Scott Boule
Legislative Affairs and Community Outreach Manager
Transbay Joint Powers Authority
201 Mission Street, Suite 2100
San Francisco, CA 94105

Re: Comments on Transbay Joint Powers Authority (“TJPA”) and Federal Transit Administration (“FTA”) Transbay Transit Center Program Draft SEIS/SEIR dated December 15, 2015
Our File No.: 1875.06

4) Fourth and Townsend Underground Station location

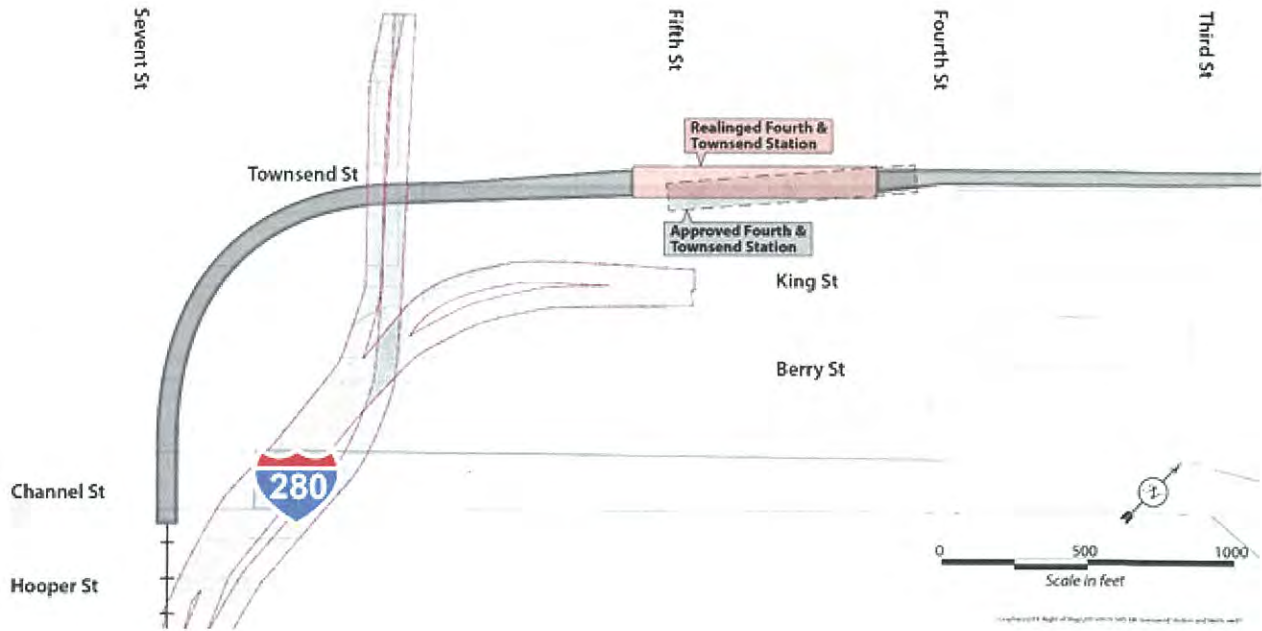
It is unclear how a relocated Caltrain station on Townsend could possibly accommodate the ridership demand from Mission Bay including UCSF, AT&T Park and the proposed Warriors Arena.

The SEIR should consider relocating the Townsend station to 7th Street and providing connectivity to the Central Subway via an extension of the N line connecting to the Mission Bay loop via 16th Street. This station should be designed to accommodate the Grand Boulevard at a later date.

cannot be relocated. SFPUC is also currently planning a connection (Central Bayside Improvement Project) to the Berry Street box, which would directly conflict with a station at the commenter's suggested location on Seventh Street. In addition to conflicts with SFPUC facilities, the fiber optic backbone for AT&T is in the Seventh Street right-of-way in the vicinity of the suggested underground station and would conflict as well. Disruption of this fiber optic backbone would have economic impacts to residents and businesses throughout San Francisco.

5) 7th Street Tunnel Stub Box

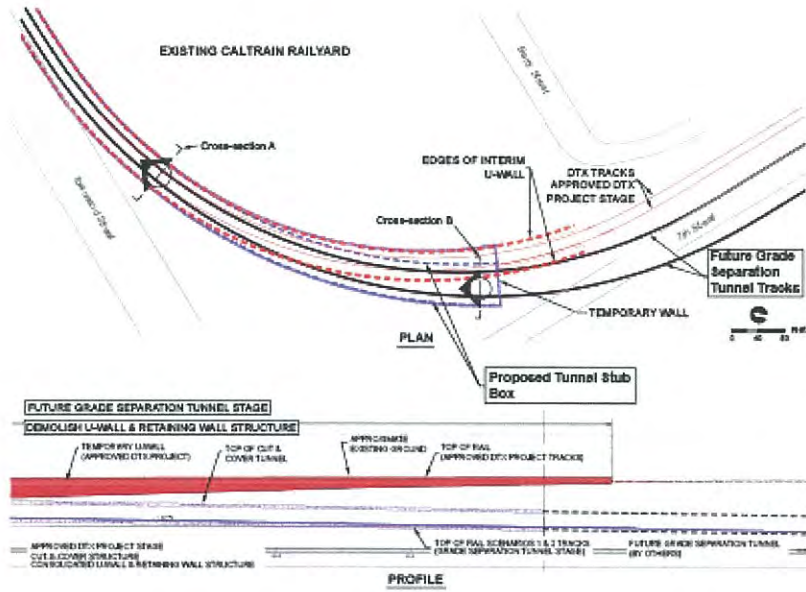
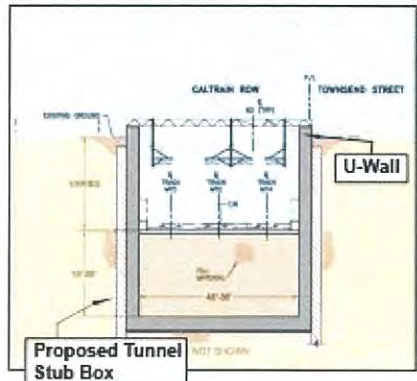
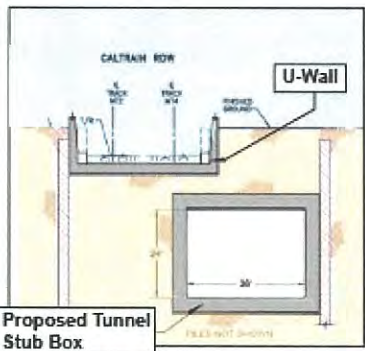
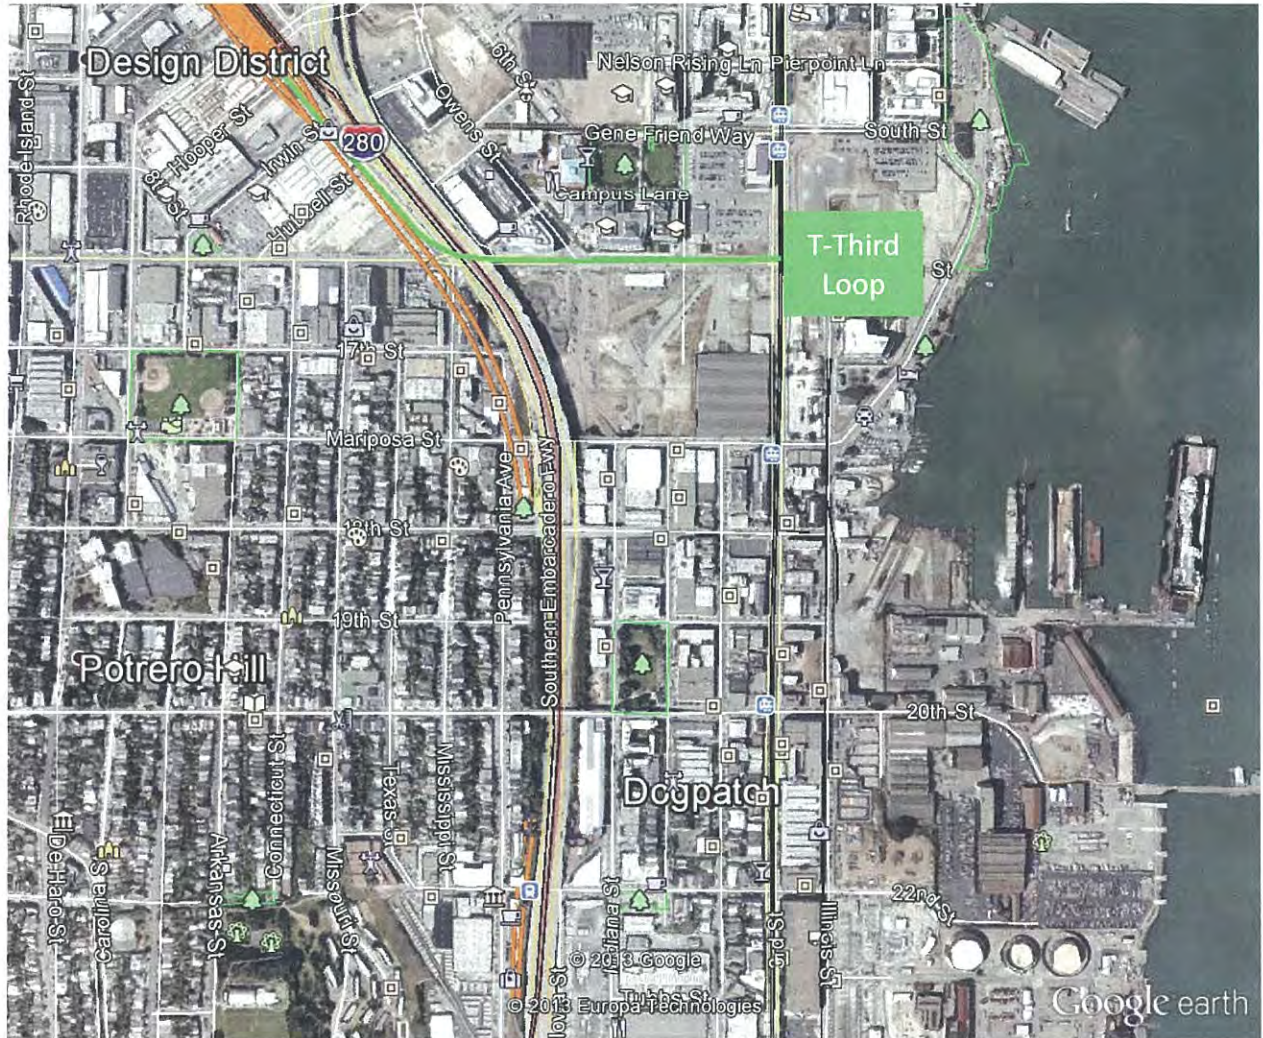
The SEIR proposes to terminate the DTX on 7th Street with a “tunnel stub box” designed to accommodate a future 16th Street grade separation.

The SEIR should consider a direct connection to the Planning Department's Pennsylvania Avenue RAB study alternative. This would achieve 16th Street Grade separation as soon as Caltrain operations are relocated to the Transbay terminal and would save hundreds of millions by eliminating cut & cover structures @ 7th & Townsend

Direct connection to a grade separation tunnel, as recommended by the commenter, would cause years of delay as there is no approved tunnel to which the proposed tunnel stub box could connect. This proposed project component has been included in the Draft SEIS/EIR to facilitate future below-grade Caltrain and HSR service and preserve future grade separation options. Such plans would need to undergo environmental review, complete engineering, and obtain funding, all of which would be at an unidentified time in the future. The approved Transbay Program includes a U-wall for Caltrain and future HSR trains to transition from at-grade operations to the underground alignment to the Transit Center.

6) Turnback Track impacts on 16th Street grade crossing

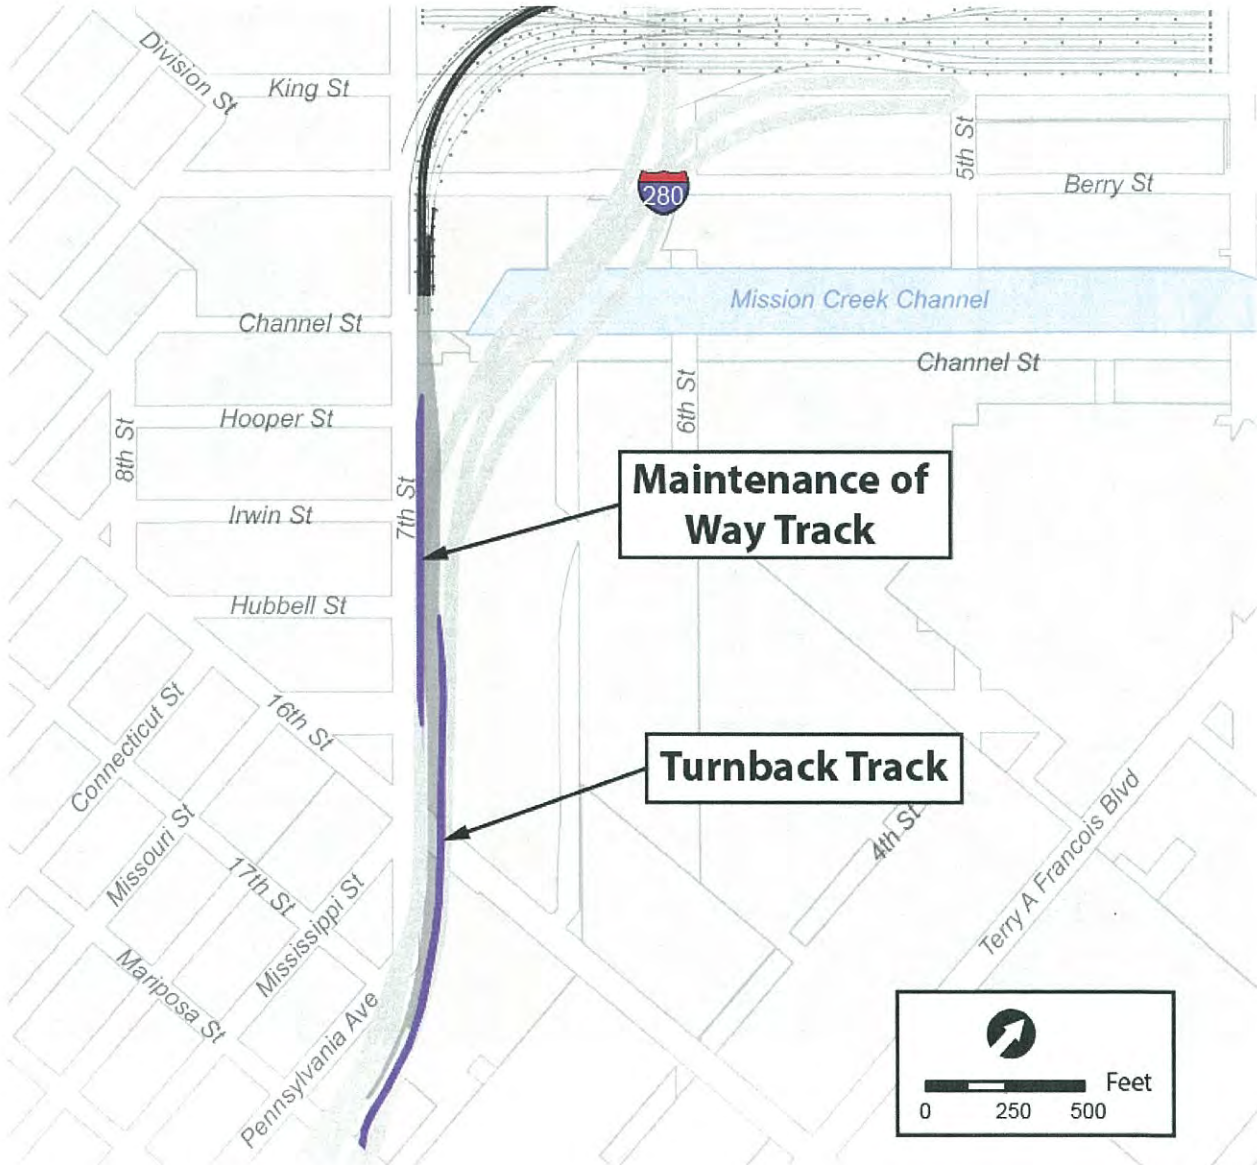
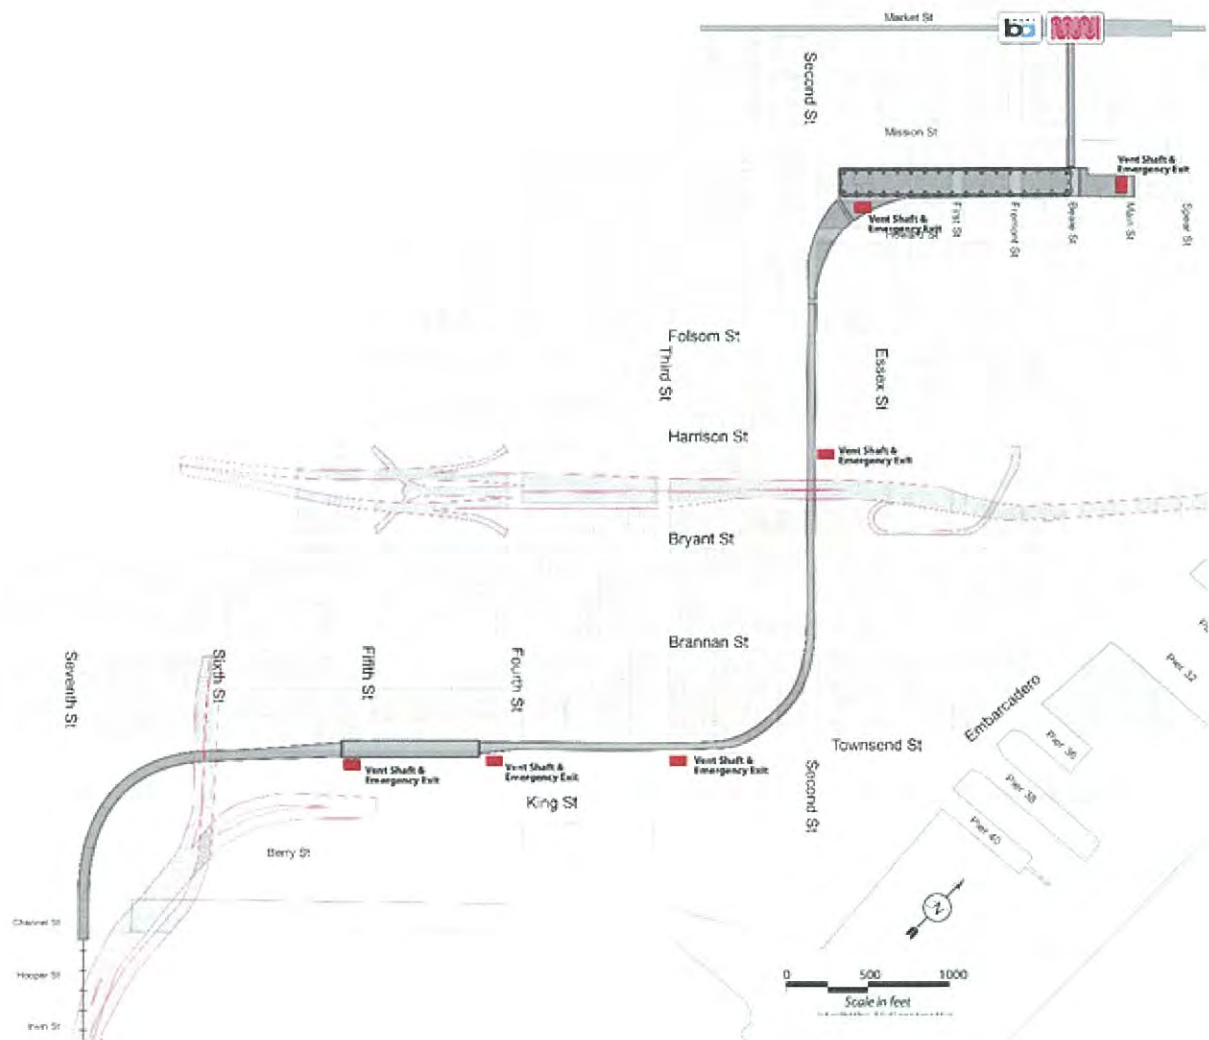
The SEIR proposes the addition of two additional tracks on 7th Street, including a turnback track across 16th Street, thereby increasing gate downtime for each train crossing by an additional 10 seconds (10 minutes per day).

The SEIR should consider a direct connection to the planning department's Pennsylvania Avenue alternative (see recommendation #5 above) and turn trains around further south. The SEIR should also consider the abandoned tunnel #1 for storage.

For additional information regarding the turnback track impacts on 16th Street circulation, please see Master Response 2.

Recommendation #7

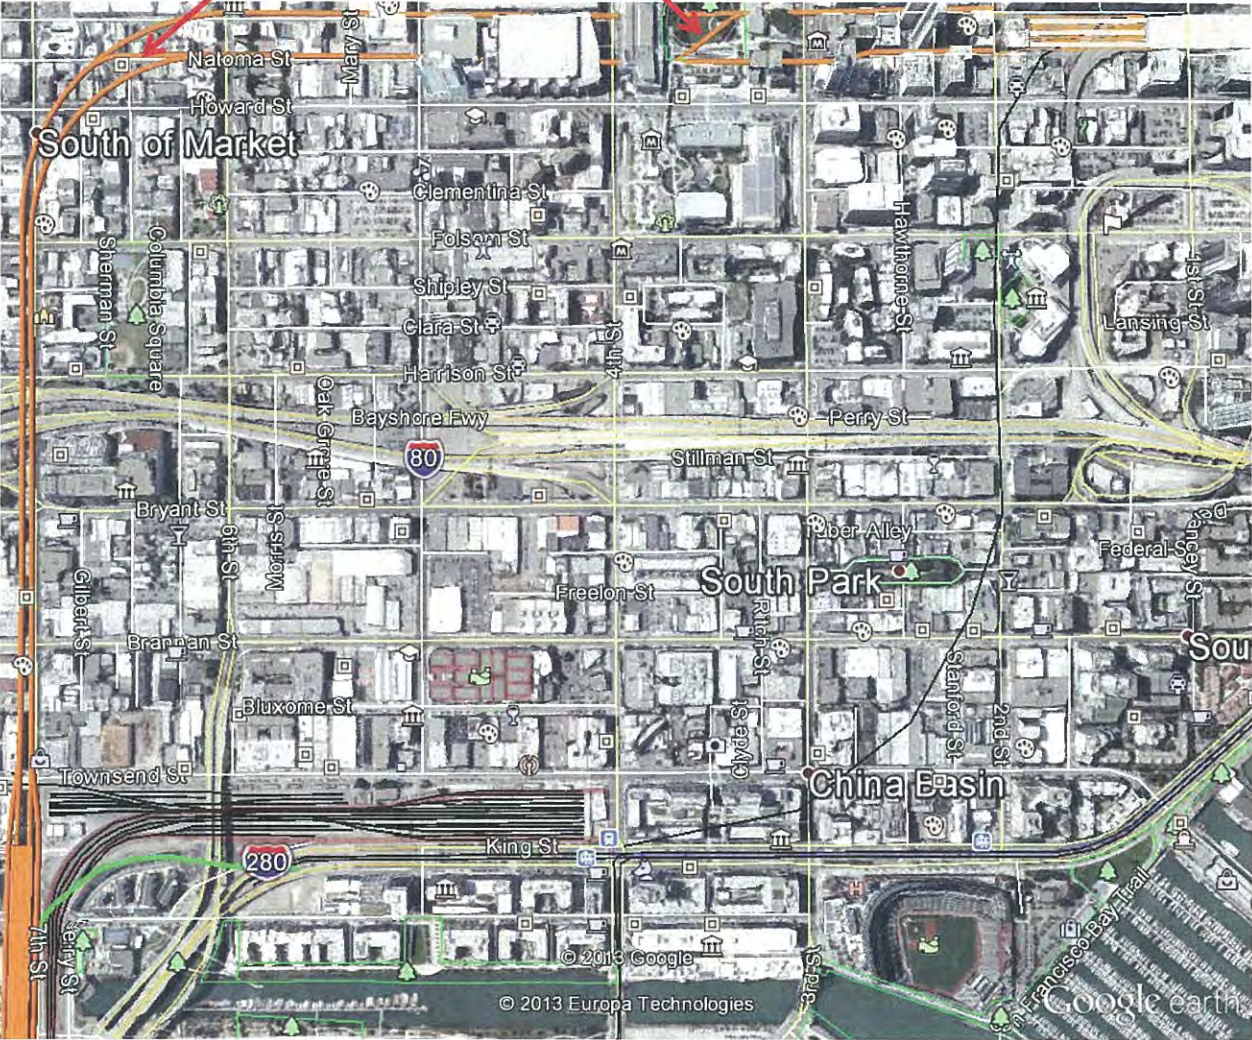
The SEIR should consider an alternate alignment designed to enable an 80 MPH approach to the Transbay Transit Center.

Because the Transit Center is a terminal station, train speeds entering the station would be slow regardless of the curve radius. The tracks (and one mined crossover) shown in the commenter's figure associated with Recommendation #7 would pass underneath the Moscone Center. This suggested alignment would not be feasible because much of the Moscone facility, including its underground parking, is below

grade and would be prohibitively expensive to remove in order to accommodate the commenter's recommendation. Going deeper to avoid the basement of the Moscone Center would result in a grade that is too steep for the trains to enter the Transit Center.
